DRAINAGE LETTER REPORT

**STRUTHERS RANCH POLARIS
847 STRUTHERS RANCH ROAD
LOTS 1-2, STRUTHERS RANCH SUBDIVISION FILING NO. 4**

August 10, 2022
Revised October 21, 2022

**JPS Project No. 032203
PCD Filing No. PPR2248**

DETENTION BASIN OUTLET STRUCTURE DESIGN

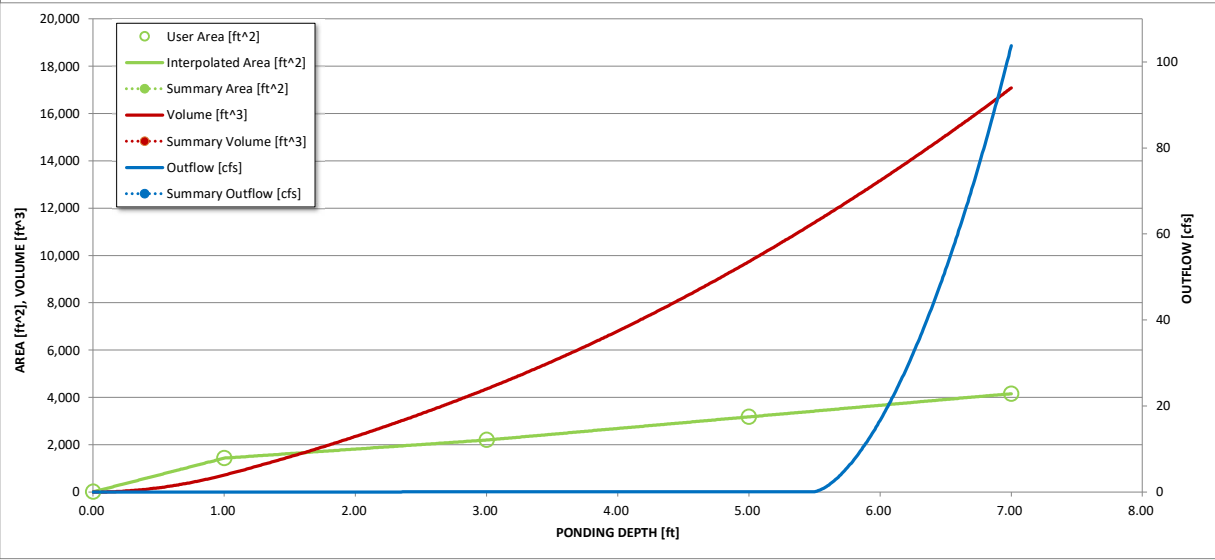
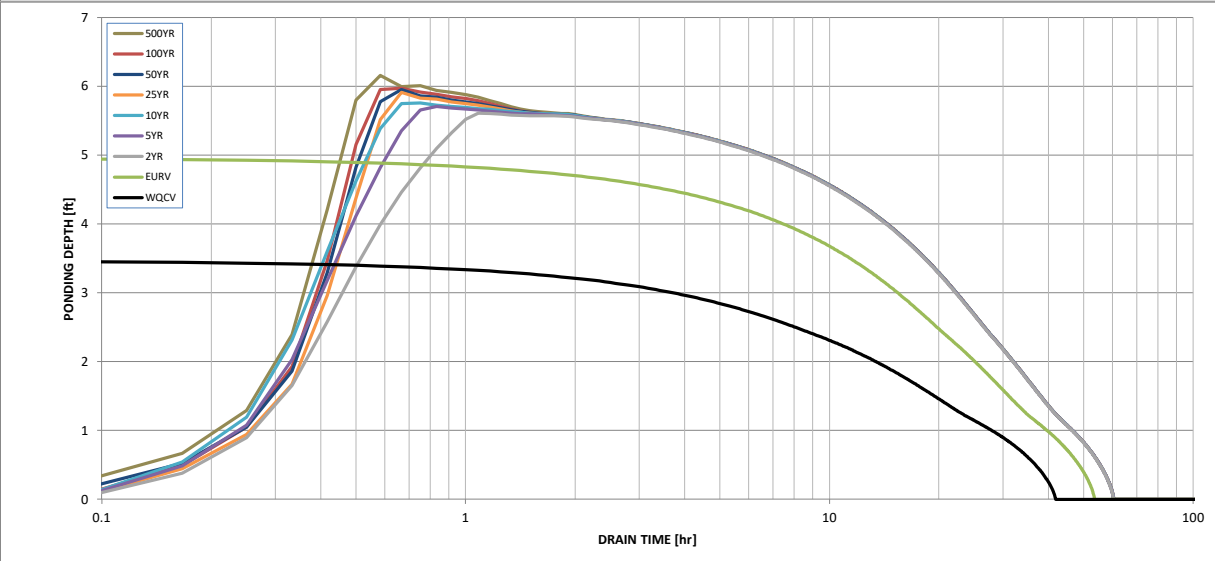
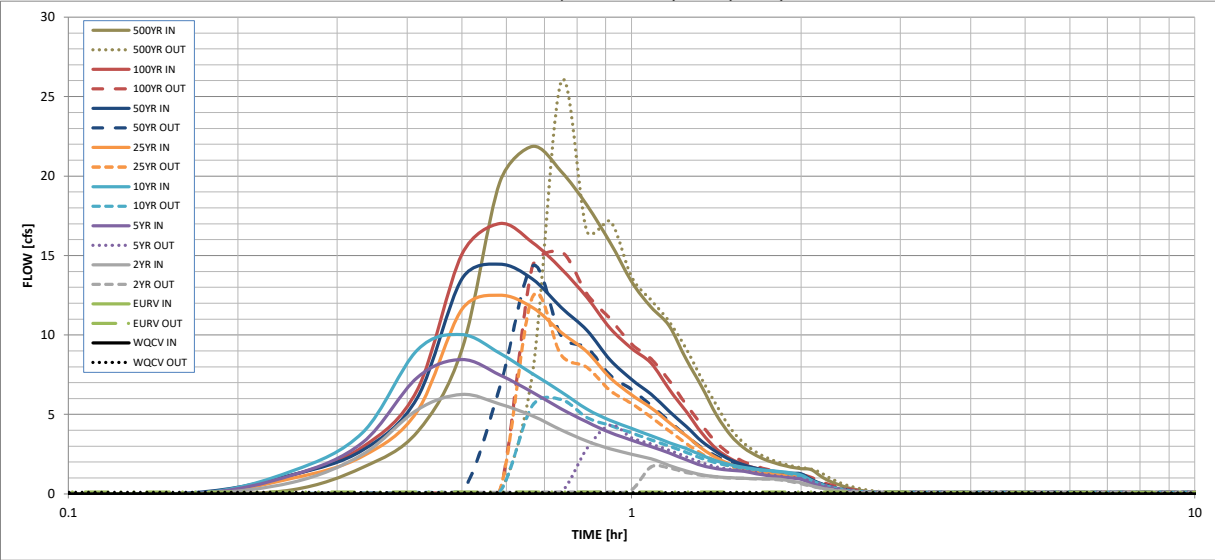
What happened? Why all "N/As" now with this submittal? Complete these sections per my comments from Review #1.

To be reviewed on the resubmittal once overflow weir data is completed.

SHEET: **D1**

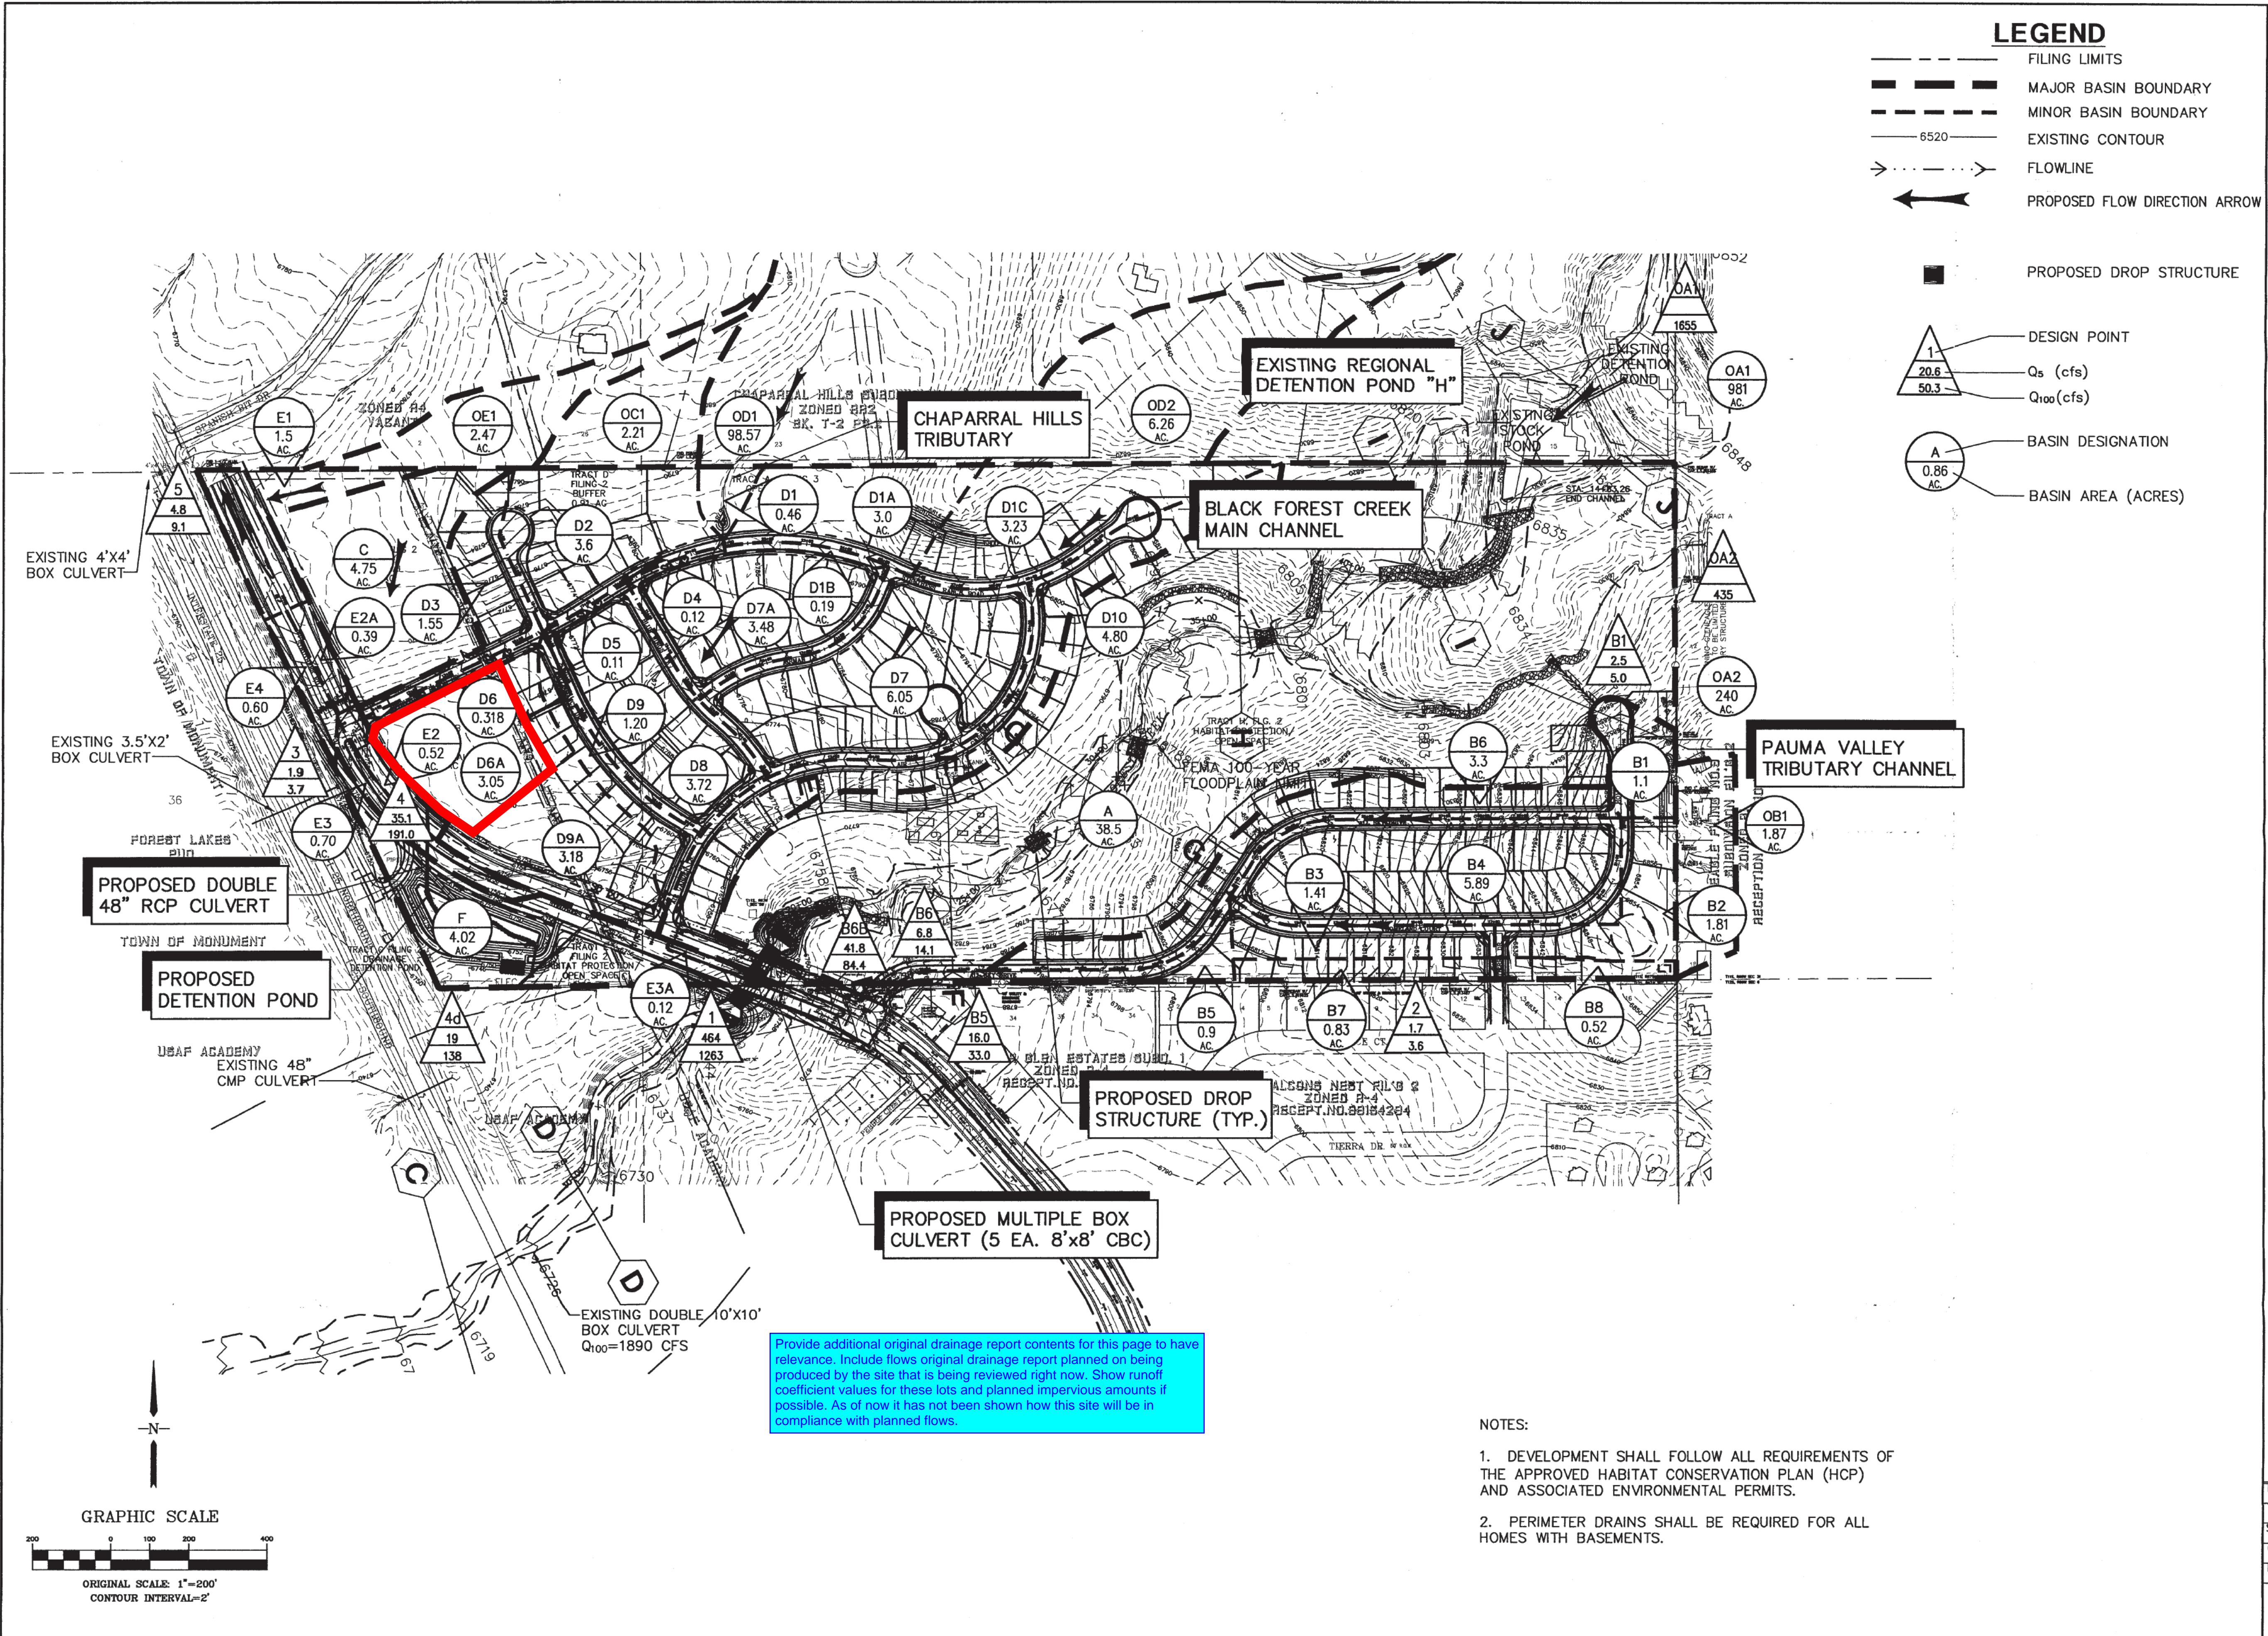
Provide additional original drainage report contents for this page to have relevance. Include flows original drainage report planned on being produced by the site that is being reviewed right now. Show runoff coefficient values for these lots and planned impervious amounts if possible. As of now it has not been shown how this site will be in compliance with planned flows.
